SUBJECT: Forwards response to NRC request for addl info re Safety Sys Functional Insp Unresolved Items 88-201-2A, 2B & 2C.

Re: Nine Mile Point Unit 1  
Docket No. 50-220  
DPR-63  
TAC No. 73043

ADDITIONAL INFORMATION

FIGURE 1

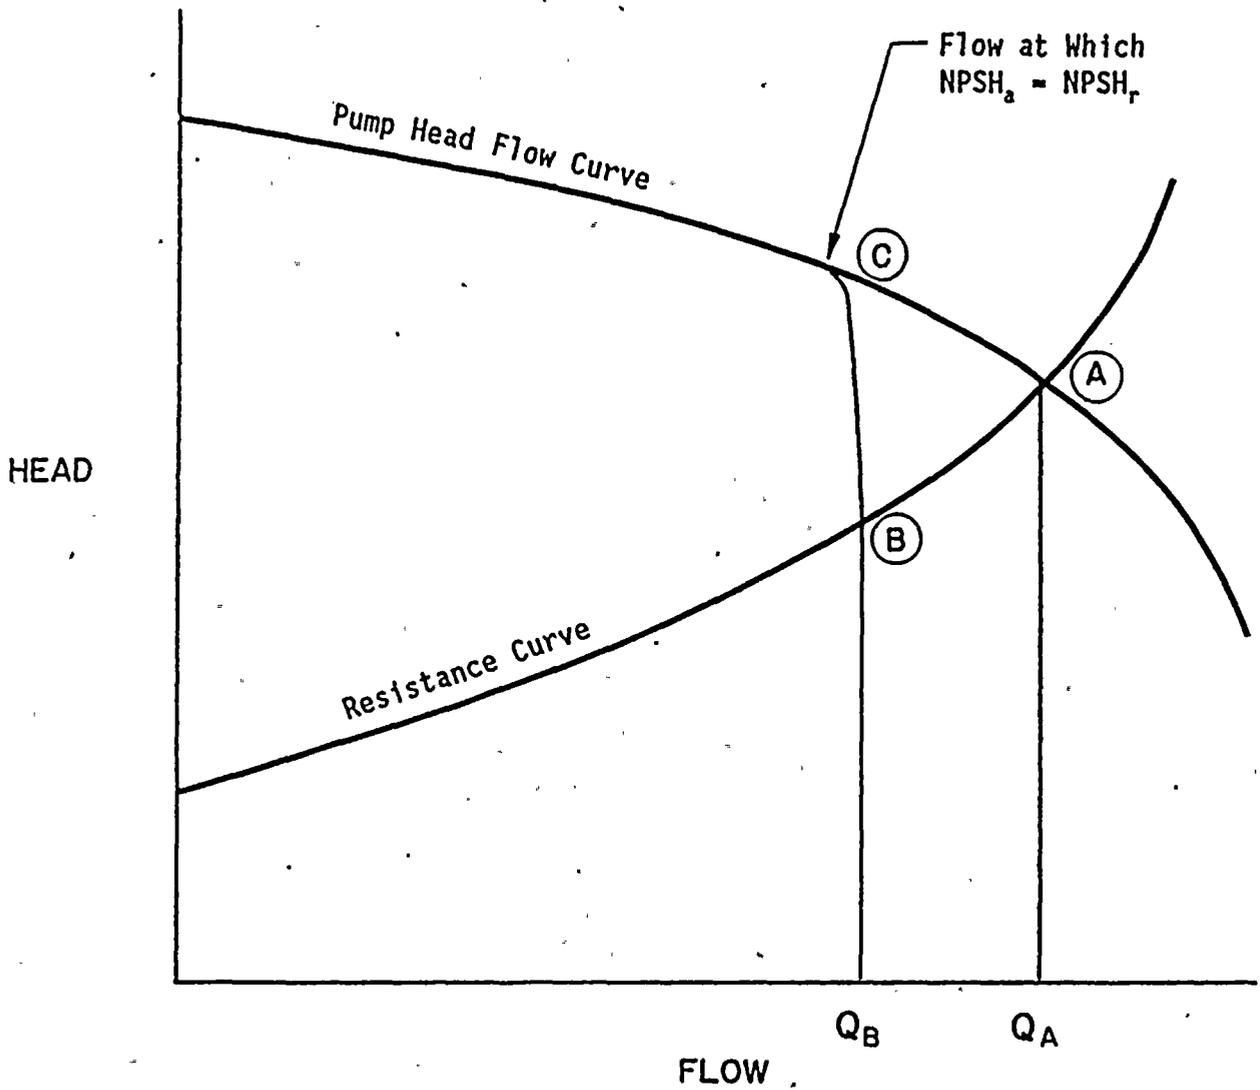
2. Unresolved Item 88-201-2B. The licensee's response states that NPSH calculations indicate that pump cavitation is expected to exist for 6 hours. The licensee should provide a verification from the pump manufacturer that the pumps will be able to perform their safety function during and following the 6 hours of cavitation. An analysis of expected vibration should be evaluated with respect to the other system components. In addition, expected operator actions during and

Flow Rate. The effect of operating a pump at an available  $NPSH_a$  less than the required  $NPSH_r$  would be to reduce the flow through the pump. However, the flow will be at least as high as the flow from the pump performance curves where the available  $NPSH_a$  is equal to the required  $NPSH_r$ . This conclusion is supported by experimental test data from Minami, et. al, (1) and illustrated in Figure 1. If the available  $NPSH_a$  is greater than or equal to the required  $NPSH_r$ , then the flow will be  $Q_A$  which is the intersection of the pump head-flow curve and the resistance curve. However, if the available  $NPSH_a$  is less than the required  $NPSH_r$ , the flow will be  $Q_B$  which is the intersection of the resistance curve and the flow at which the available  $NPSH_a$  is equal to the required  $NPSH_r$ .

For the NMP-1 core spray pumps, the values are:

<u>Flow (gpm)</u>	<u><math>NPSH_a</math> (ft)</u>	<u><math>NPSH_r</math> (ft)</u>
5000	36	39
4800	36	36

Therefore, at an available  $NPSH_a$  of 36 ft, the flow through the core spray pumps will be at least 4800 gpm, which is consistent with calculations previously submitted to the NRC.

# CAVITATION - TYPICAL CHARACTERISTICS / DOMAINS

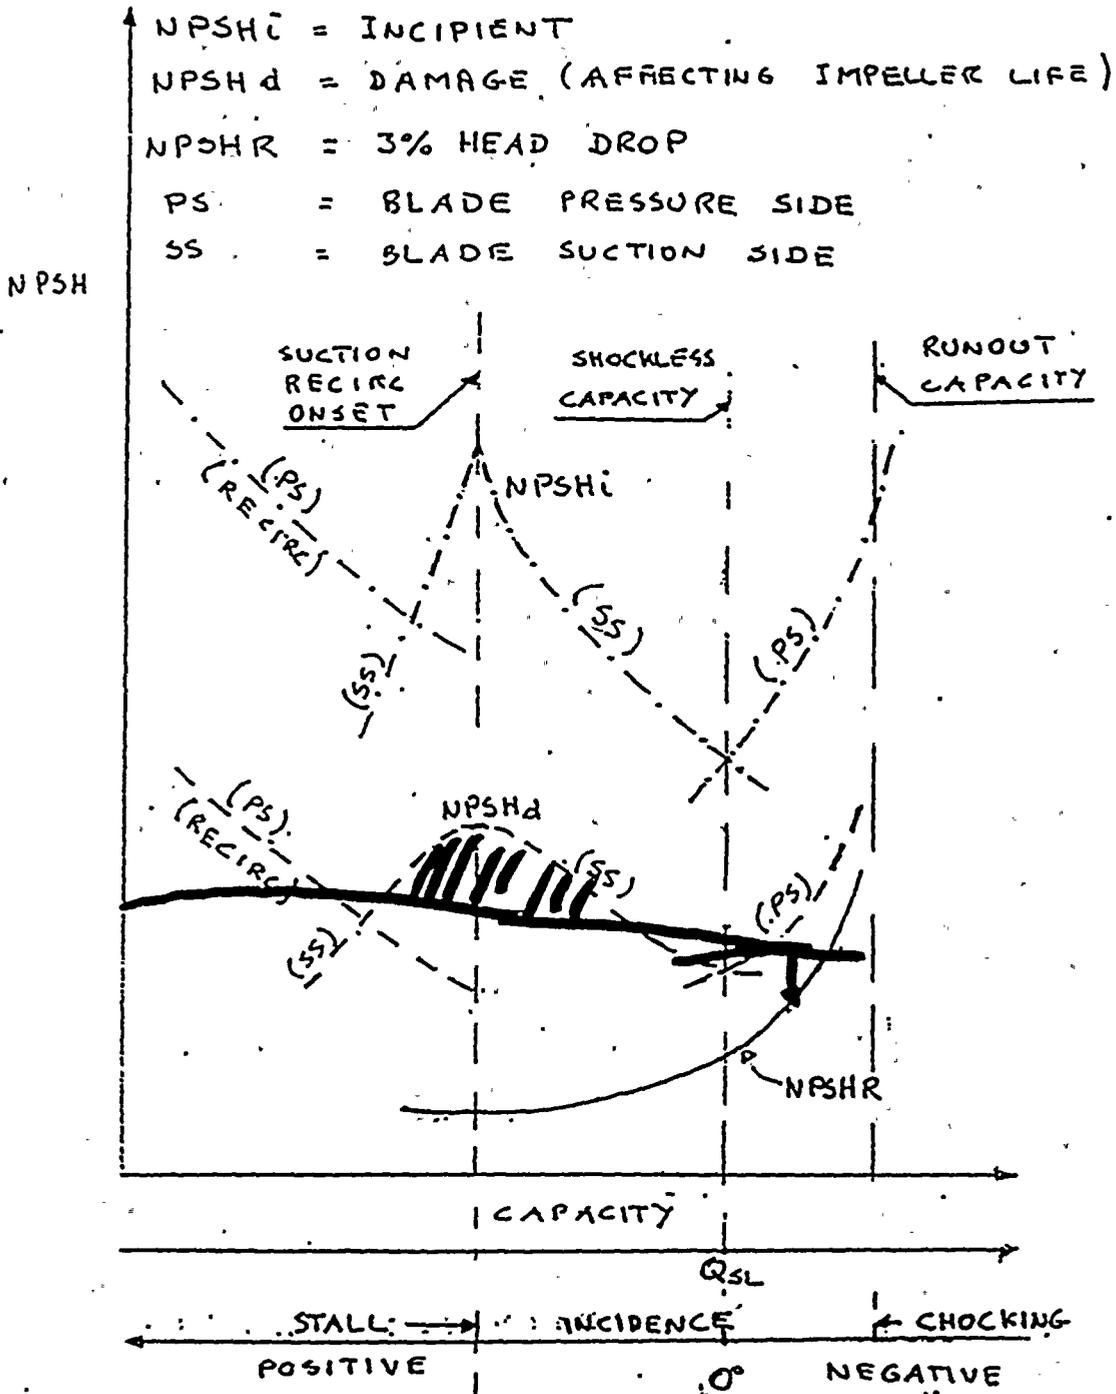
A brief summary of the discussion is best explained by reference to attachment 3, Cavitation Domains. The upper family of curves identified as NPSHi (incipient) identifies the NPSHA value at which cavitation bubbles first appear. At this level, cavitation bubbles are less than 2 millimeters in length on the leading edge of the impeller vane, and no damage will occur.

As the NPSHA value is reduced, we reach the range identified as NPSHd (damage) where cavitation bubbles exceed about 10 millimeters in length and as they collapse on the impeller vane surface, pitting damage may take place.

Further reduction in NPSHA values will result in an increase in length of the cavitation bubbles with an increase in damage to the impeller. However, although cavitation bubble length continues to increase as NPSHA decreases below NPSHd, noise and damage to the impeller reaches a peak and then begins to decrease as the NPSHA is further lowered. This is due to the fact that the cavitation bubble is becoming more detached from the vane surface and implosion of the vapor bubble is not fully impinging on the surface and causing pitting.

When operating with NPSHA equal to the NPSHR value, there are substantial cavitation bubbles being formed on the impeller vanes and they reach a degree where they begin to block some of the flow area between vanes. This results in a reduction of flow and total head output. The Hydraulic Institute defines the NPSHR value as that which causes a reduction in pump total head of three percent.

Further reduction in NPSHA to values lower than NPSHR will increase the length and volume of cavitation bubbles and also reduce the impeller output in flow and total head. However, since much of this increase in cavitation bubbles is detached from the vane surface, increase in damage to the impeller is expected to be minimal.
